UNITED STATES PATENT AND TRADEMARK OFFICE

| 10/547,965 | 09/08/2005 | Hanjo Yang | 1884 02 | 6462 |

| Office Action Summary | Application No. 10/547,965 | Applicant(s) YANG, HANJO |

DETAILED ACTION

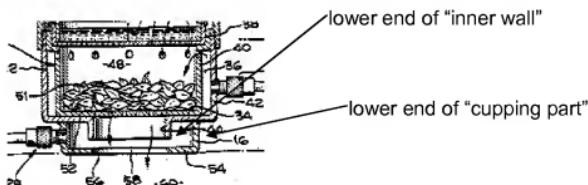
9. Claims 1 and 6 are rejected under 35 U.S.C. 103(a) as being unpatentable over US Pat. No: 3946733 to Han (hereinafter "Han"). Han teaches a cupping and moxibustion device, which includes a moxa pot (32) located on the upper portion (12) for containing moxa (51) therein, a moxibustion part formed just above the treatment opening (56) of the lower treatment portion (58) to communicate with the moxa pot (32), and a cupping part (16) divided from the upper portion and the moxibustion part and located around the moxibustion part (fig. 2), comprising: a body (10) having a seat (34) formed therein for seating the moxa pot (32) inside the body and a smoke discharge hole (28) formed on a side thereof, the smoke discharge hole being located below the seat and above the moxibustion part to communicate with the moxa pot (col. 3, lines 1-26); an air pump (18) connected with the air suction hole (22) to supply air into the body, whereby moxa (51) contained in the moxa pot (32) is burned when the air pump is operated and the air is forcibly induced into the body, at which time, heat and smoke of

the moxa are moved downwardly toward the moxibustion part, and then, discharged to the outside through the smoke discharge hole (col. 3, line 65 to col. 4, line 10). The air pump (18) is connected to the air suction hole and an air suction pipe, and a valve (24) is mounted on the air suction pipe (20), whereby an amount of the air supplied into the body can be controlled. The seat (34) is located on the upper portion (12) of the body (10) to catch the moxa pot (32) therein, and the moxibustion and cupping part respectively are located on the lower portion and are formed integrally in such a way as to form the body and are divided by the inner wall (44). The inner wall comprises a lower end and the cupping part (16) comprises a lower end, wherein the lower end of the inner wall and the lower end of the cupping part are in the same plane (see depiction). Regarding the indefinite nature of the claim with respect to the "two different pressures" applied to the skin as noted above, it is noted that this is also believed to be taught by Han since the moxibustion part and the cupping part would effect two different pressures on the skin of the patient, and the cupping part encloses a "cupped space" as demonstrated in the figure below.

The body also includes an air discharge hole (28) formed on the outer wall thereof to communicate with the cupping part (16), and an opening and closing unit (30) is inserted into the air discharge hole, for maintaining pressure inside the cupped space by controlling an air flow between the inside and the outside of the cupping part independently from the moxibustion part (col. 3, lines 61-65).

Han however does not teach that air suction hole (22) is connected to the lid (14) of the body (10). Applicant has not disclosed that having the air suction hole located on the lid instead of on the body of the moxibustion device solves any stated problem or is for any particular purpose. Moreover, it appears that the air hole placement of Han, or applicant's invention, would perform equally well with the hole for the air pump at any location above the base of the moxa pot. Accordingly, it would have been *prima facie* obvious to one of ordinary skill in the art at the time the invention was made to have modified Han such that the port for the air pump is located on the lid because such a modification would have been considered a mere design consideration which fails to patentably distinguish over Han.
